Horsham District Cycling Forum: Comments to the Inspector on Documents REP/847002/007A & 007B- PBA Transport, Infrastructure and Flood Risk

Option to reduce traffic on Rusper Rd, and increase sustainable transport use by improving conditions for cycling.

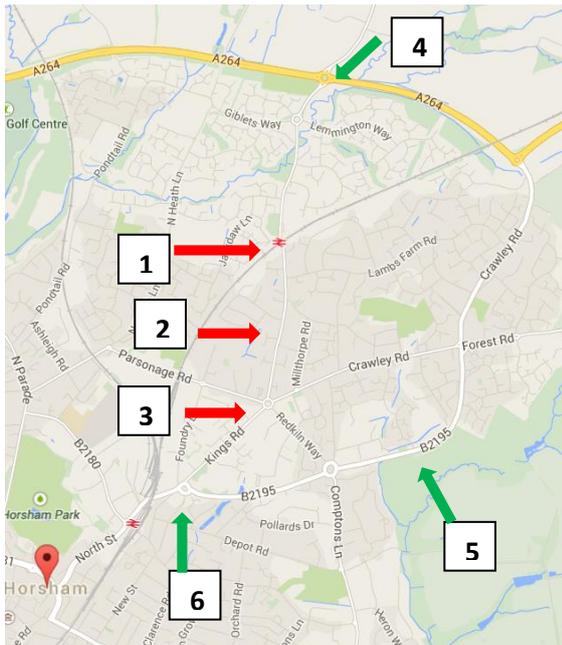
Problems with proposed Rusper Rd route for cars:

1. Level crossing slows journey
2. Many side roads and properties fronting road
3. Roundabout above capacity without widening

One option for significant traffic reduction is to restrict the Rusper Rd site access to walking, cycling (and, possibly, buses) only. Car traffic would route via the Moorhead roundabout / Harwood Rd and the A24. This would also cut out rat-running through town by existing residents. Conditions for cycling along this direct route could be significantly improved resulting in a modal shift towards cycling.

Alternative:

4. Restrict vehicle access at Rusper Rd roundabout
5. Route traffic via faster Harwood Rd, B2195
6. Routes meet

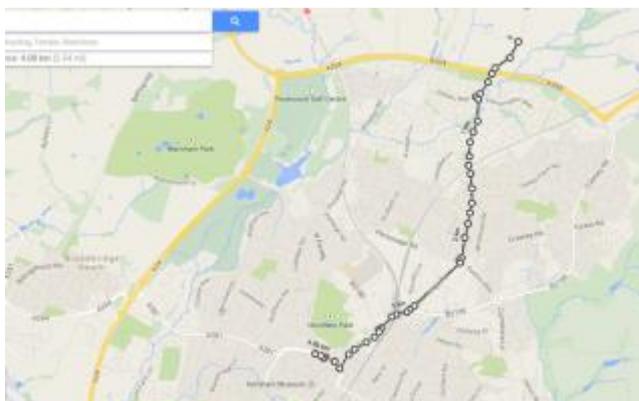
The only route between the development and Horsham town centre that is suitable for an adult or child using Bikeability Level 2 skills is via Pondtail Rd and the soon-to-be-completed LSTF HR4 route. This is a distance of about 5.7 miles and it is simply not credible that anyone would use it:
